**EASTERN CONNECTICUT
ENVIRONMENTAL
REVIEW TEAM
REPORT**

River Edge
Subdivision
Haddam, Connecticut

Review Date: September 26, 1989

Report Date: November 1989

LOT AND STREET LAYOUT

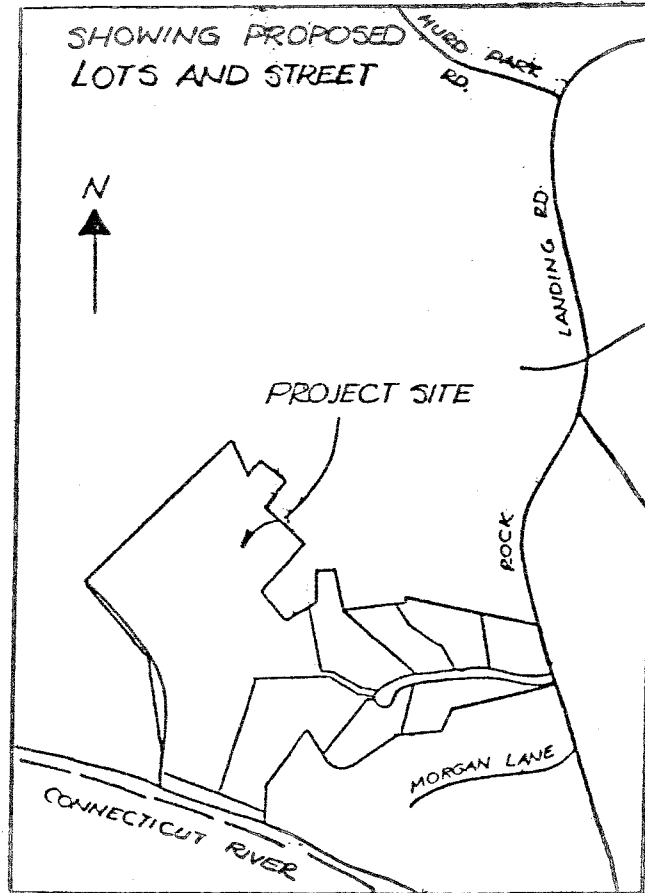
Based on present plans, the separating distance between wells on Lots 3 and 4 is about 115 feet and about 90 feet on Lots 7 and

8. Consideration should be given to increasing the separating distance of wells so that the chance for mutual interference during pumping periods will be minimized.

SOILS MAP

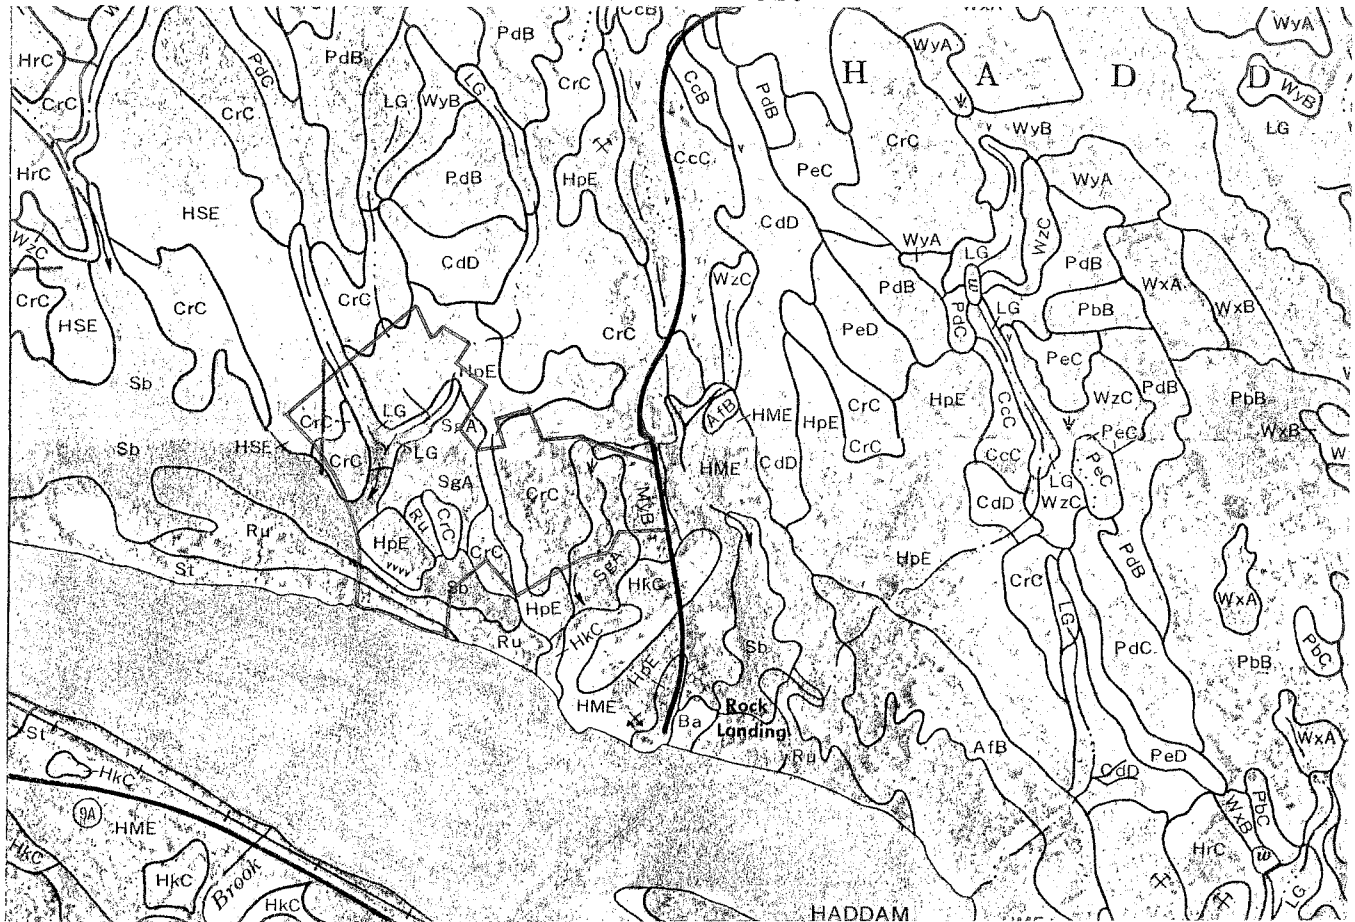
The AQ - Aquepts soil is a disturbed wetland soil which still exhibits a high seasonal water table and it can be expected to support hydrophytic vegetation. The degree of the disturbance and/or fill varies and it can only be determined by a site investigation. Because the cul-de-sac is proposed for construction above this soil, it is recommended that a soils investigation be

conducted/requested by the town to determine if the fill material is suitable as a base for the road. It could not be substantiated that all alternatives were explored by the developer to avoid the filling of this wetland.
